UNITED STATES PATENT AND TRADEMARK OFFICE

APPLICATION NO.	FILING DATE	FIRST NAMED INVENTOR	ATTORNEY DOCKET NO.	CONFIRMATION NO.
10/777,016	02/11/2004	Joe Karkosch	502336	2227
53609	7590	09/26/2005		
REINHART BOERNER VAN DEUREN LTD. 483 NORTH MULFORD ROAD SUITE 7 ROCKFORD, IL 61107			EXAMINER SELF, SHELLEY M	
			ART UNIT	PAPER NUMBER
			3725

Office Action Summary

DETAILED ACTION

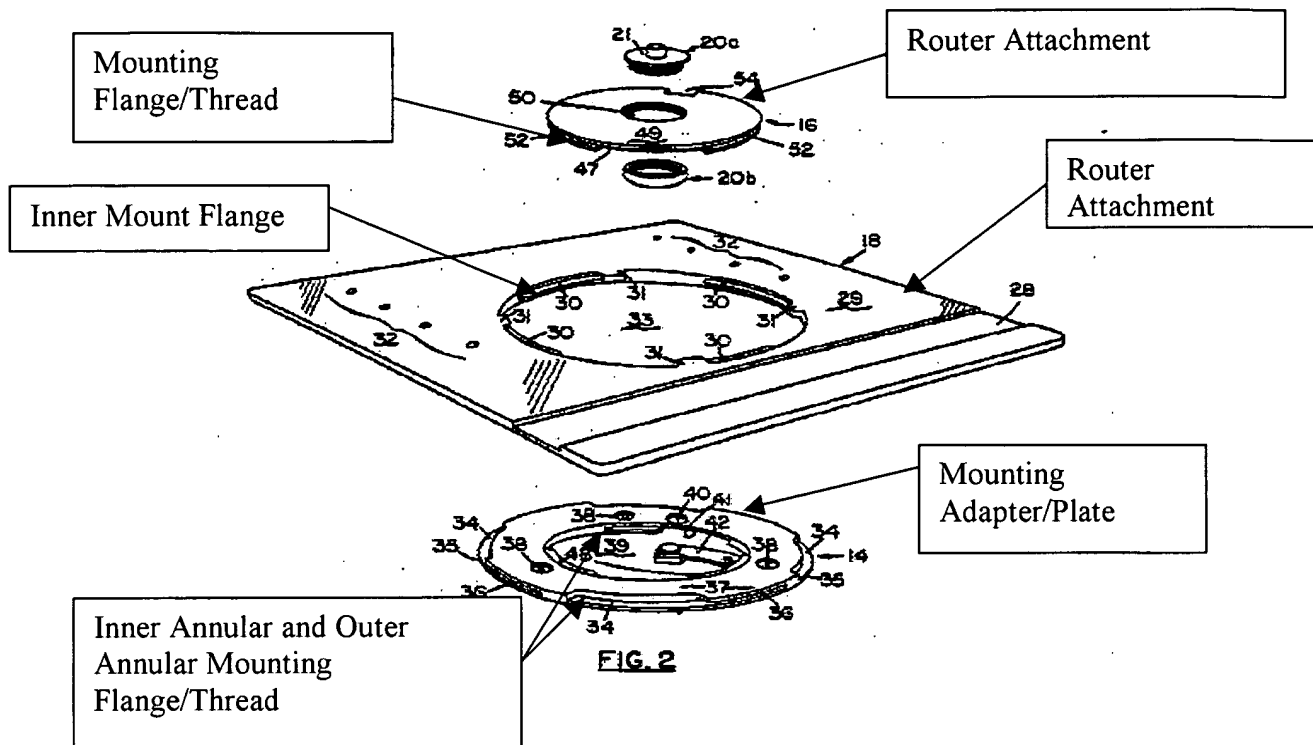
Examiner notes that the router attachment and mounting adapter are manually vertically rotatable relative to each other so as vertically lock and release the mating structure of the mounting adapter (14) to that of the router attachment (16, 18).

Further Examiner notes that the mounting adapter has two annular mounting surfaces (i.e., an inner mounting surfaces and on outer/radial mounting surface) of which two router attachments (16, 18) are able to be attached/mounted to the corresponding mounting adapter mounting surfaces.
